## Chatswood Chase Shopping Centre

### Flood Modelling Report - Addendum

- Flood modelling report (Revision F) was issued as part of a DA submission to council for development of Chatswood Chase Shopping Centre. Council ref: DA-2022/305 ePlanning Portal ref: PAN-257802

- Council has provided a request for additional information (refer letter dated 24/01/2023) in regard to the DA with specific requests in response to the flood report.

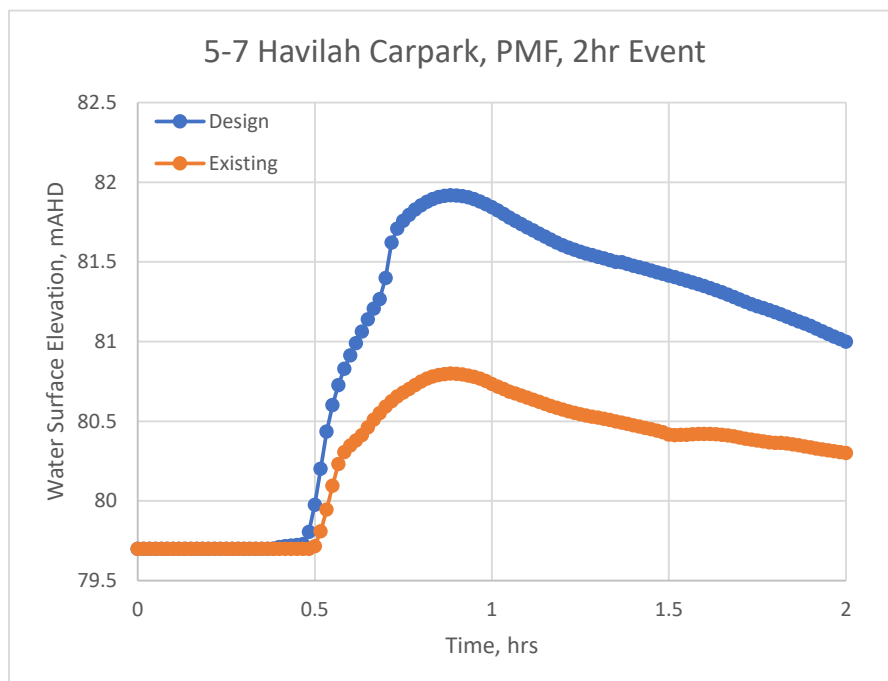
*Item 12e - There is up to a 1.0m increase in water depth at 5-7 Havilah Street basement parking area in the PMF event. The engineer is to provide commentary on the duration of the inundation. This change will increase the depth of PMF flooding to 1.9m deep. The applicant is to provide evidence that the materials used in the basement of 5-7 Havilah Street are flood compatible up to a depth of 1.9m and the calculated velocity. The applicant should also detail how the storage in the area works.*

The WSE plot below for the design scenario shows the area remains inundated to a depth greater than 1m for 1.5 - 2 hours in the PMF event. Data for the existing scenario is also shown for comparison. Model run time was 2 hours so that is the limit of the data.

Figure 5: 1%AEP 2 hr Design WSE Afflux - 100% blockage compared to 0% blockage

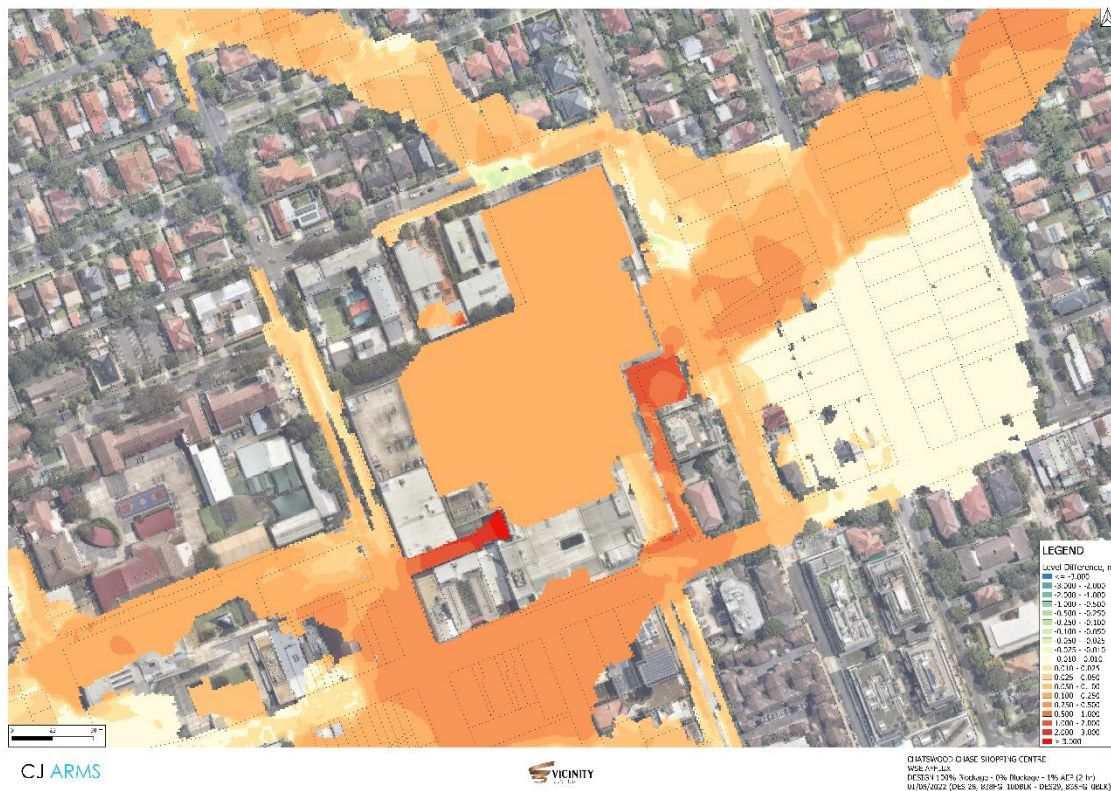
*Item 12f - Blockage scenarios have been modelled and the depth and water level plots provided. However, there is no difference plot to present the differences between flood levels in the blocked and unblocked scenarios. Difference plots are to be submitted for the blockage scenarios.*

As noted in our flood modelling report, the impacts of blockages is high and maintenance of the drainage network to reduce the incidence of blockage is critical for all properties in the area.

**Figure 8: 1% AEP 2hr Design WSE Afflux – CC10 compared to current climate scenario**

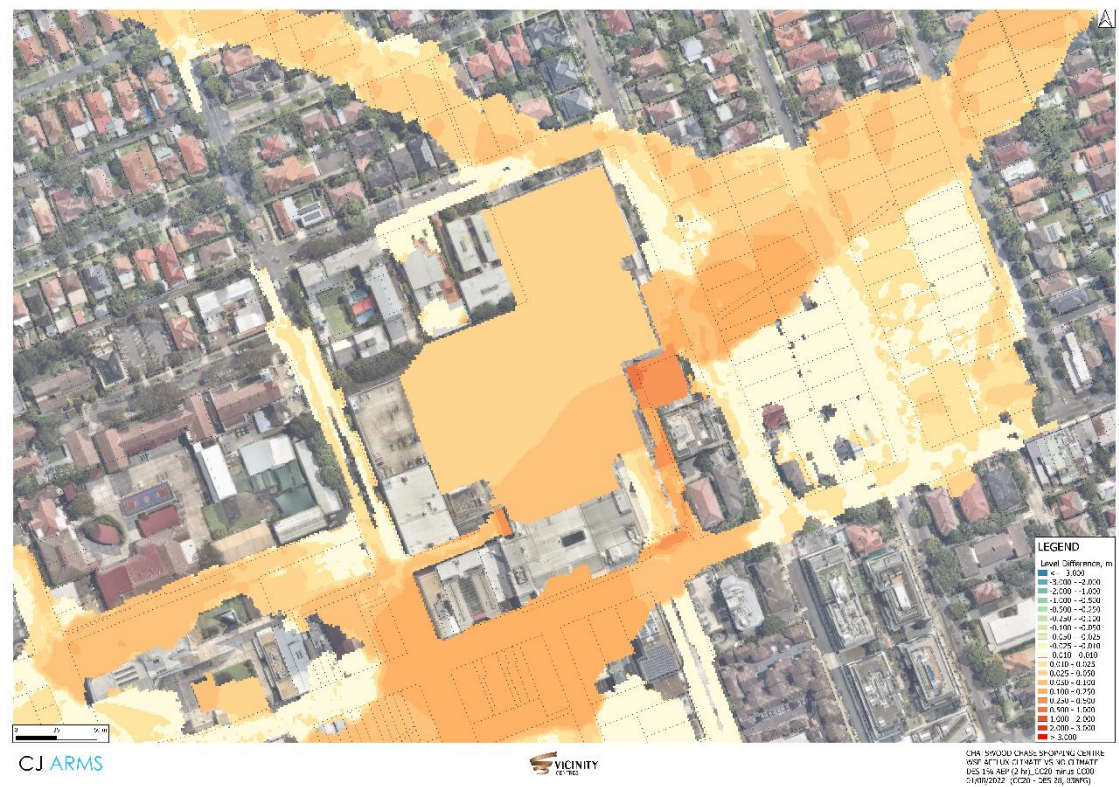
*Item 12h - Climate Change scenarios have been modelled and the depth and water level plots provided. However, there is no difference plot to present the differences between flood levels in the climate change and current climate scenarios. Difference plots are to be submitted for the climate change scenarios.*

Plots showing the difference between climate change scenarios (CC10, CC20, CC30) and the current climate for the 1% AEP design scenario are presented below. All plots show increasing flood levels in the shopping centre basement carpark, increases in flood depths in the 5-7 Havilah St. carpark and increasing flood depths in the residential areas downstream of the site.

Figure 11: Hydrograph locations

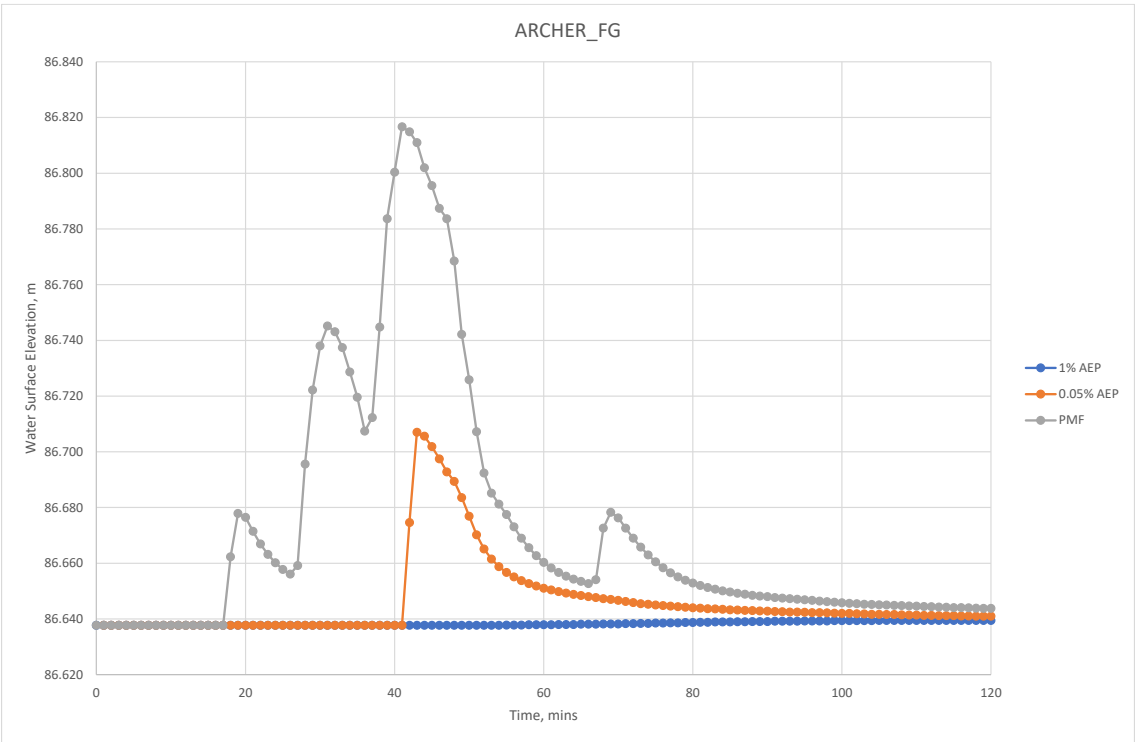
*Item 12j - The 2019 Flood Management Plan\_P2 (CJ Arms 2019) was briefly reviewed. With regards the proposed flood gates, it appears that no flood depth hydrographs have been provided to demonstrate the timing of flood and possible available warning time before the flood depths reach unsafe levels. Additionally, no indication is given of the indicative time available to deploy flood barriers manually. Please advise if there is an amended plans that addresses these issues.*

An updated Flood Management Plan will be provided. Refer to updated management plans for flood warnings and manual flood barrier deployment strategy. Hydrographs for primary flood gate locations (refer Figure 11) have been provided below, however, please note: flood barrier deployment is dependent primarily on BOM warnings not the start of rainfall events.

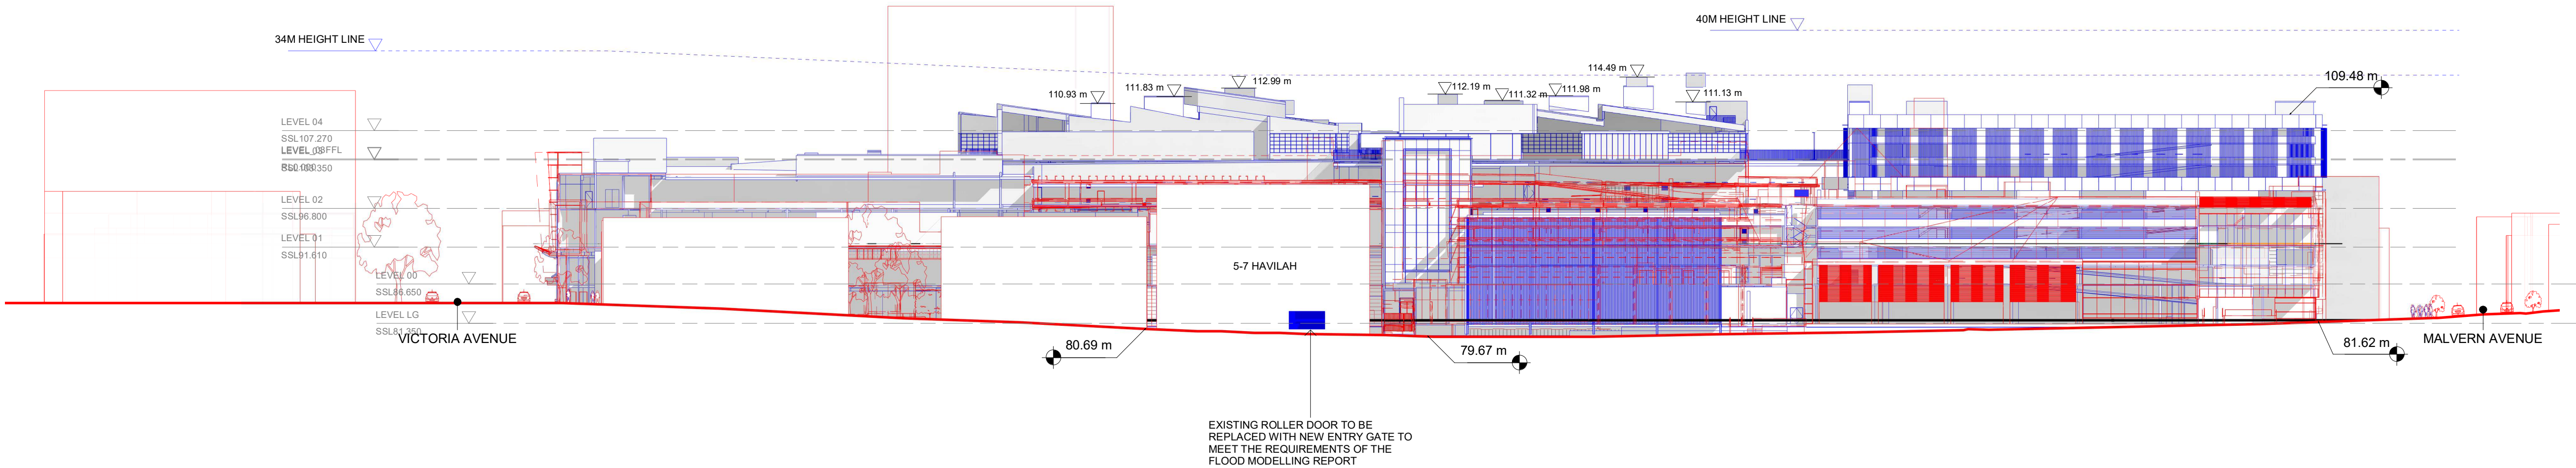
It would be necessary to assess the property and building from a structural perspective to ensure that the building structure is capable of withstanding water depths and velocities as proposed for the storm events as required by structural codes and Australian Standards.

The flood water depths and velocities per storm event are shown in the extract below.
